1. In CSR for Tankers, the critical shear stress  $\tau_{cr}$  derived by the following formulas according to Case 6 of Table 10.3.1 takes into account reducing strength due to an effective cross sectional area reduction for shear in addition to the effects of a buckling strength reduction due to an opening.

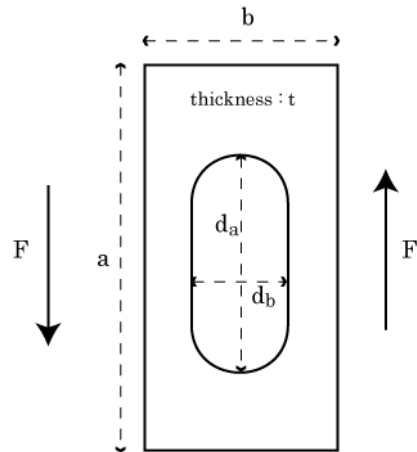
In this case,  $\tau_{work1}$  is taken as the mean shear stress for the whole panel including the opening (red part).

3. However, in the common interpretation CI-T3, a shear stress correction taking into account the stress increase due to the opening in accordance with Table PR1 is required. This means that if shear force  $F$  acts on panels with an opening, the working shear stress  $\tau_{work2}$  is derived by the following formula and is compared with the critical shear stress  $\tau_{cr}$  in consideration of an effective cross sectional area reduction due to the opening.

In this case,  $\tau_{work2}$  is taken as the mean shear stress for the red part where stress increases due to the opening.

We feel that the effective cross sectional area reduction due to an opening may be considered twice in the assessment procedure according to CI-T3 and this is too strict.

4. Our understanding is that working shear stress should be assessed by the assessment procedure in 2 above.

Please confirm.
